SLEEVE CONTROL SYSTEM  
 O/G JUNCTION RELAY SET  
 TOLL-AM.X. WITH TRK OFFER  
 AND SELECTOR ACCESS TO A.M.X.  
 2000TYPE

GBU 13140

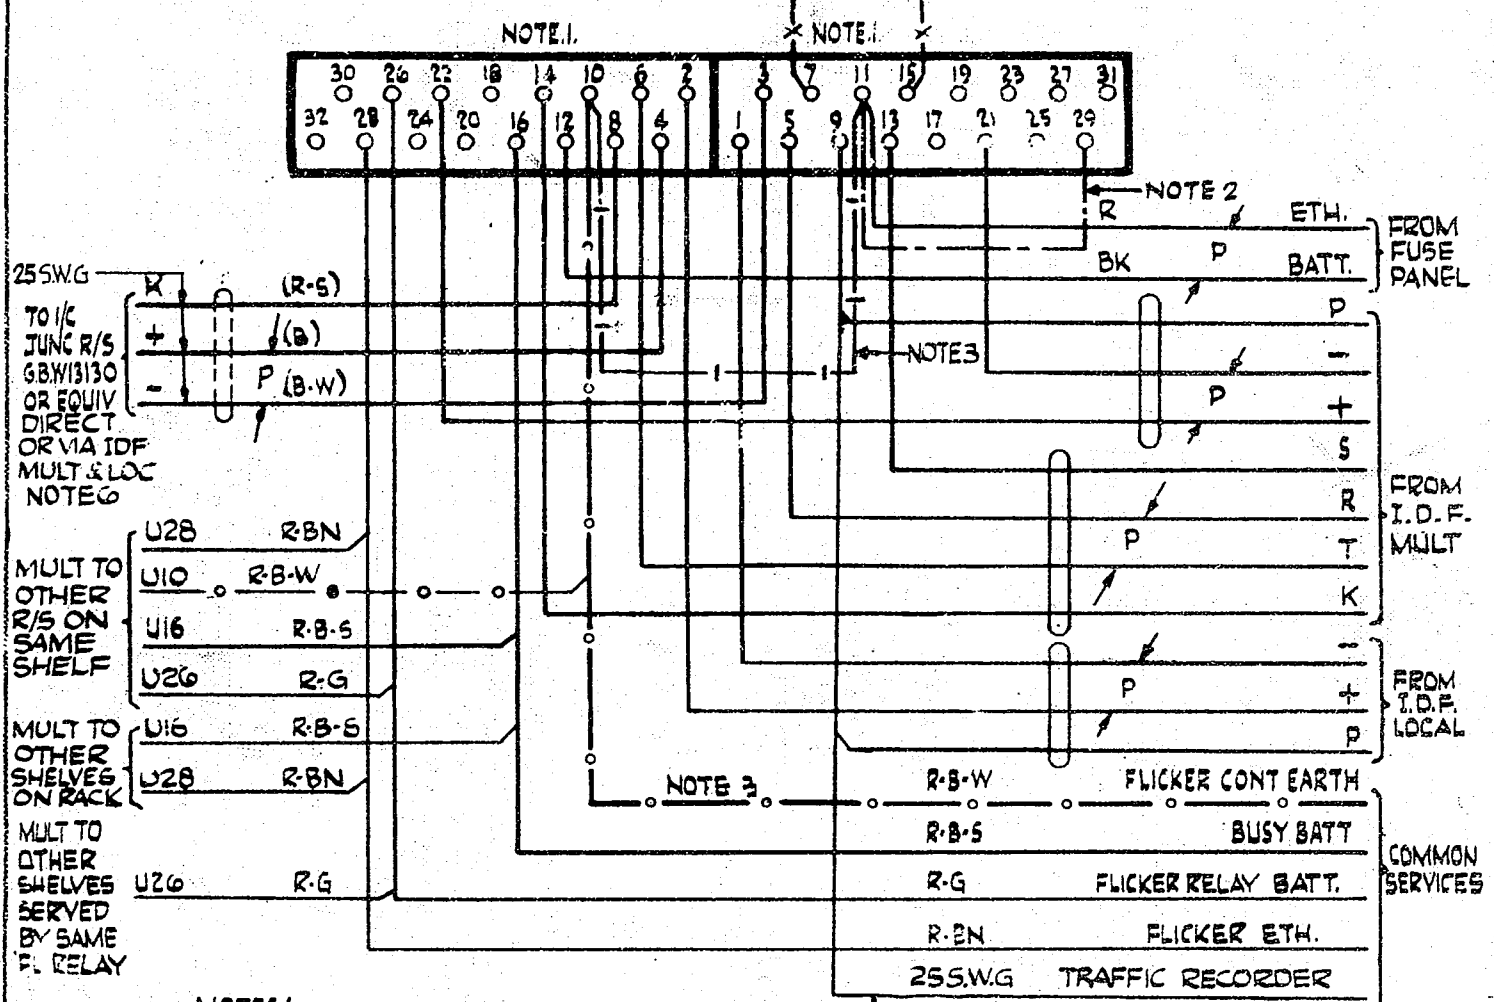
TRAFFIC RECORDER & NOTE 6 WAS NOT SHOWN	7.	25359	OK	(26350)
ALTYE WIRING FROM U3, U4 & U8 TO I.D.F. WAS NOT SHOWN	6.			
U9 & U29 WIRING MOD. WIRING TO GBW13130 WAS 205.W.G.	5.			
WIRING FROM U1, 2 & 8 REVISED	4.			
LEADS U21, 22 & 29 WERE NOT SHN. NOTE 1 MOD.	3.			
COMMON SERVICE LEADS U26 & U28 WERE NOT SHN.	2.			
	1.			
AMENDMENT PARTICULARS	ISSUE	DATE	APPD	REF — 653-21-16 TR1039-17-18 502 H
N.Z.P.O.	DRAWN	CHECKED	WIRING	CIRCUIT
	B	R.L. 5/1	R.L.
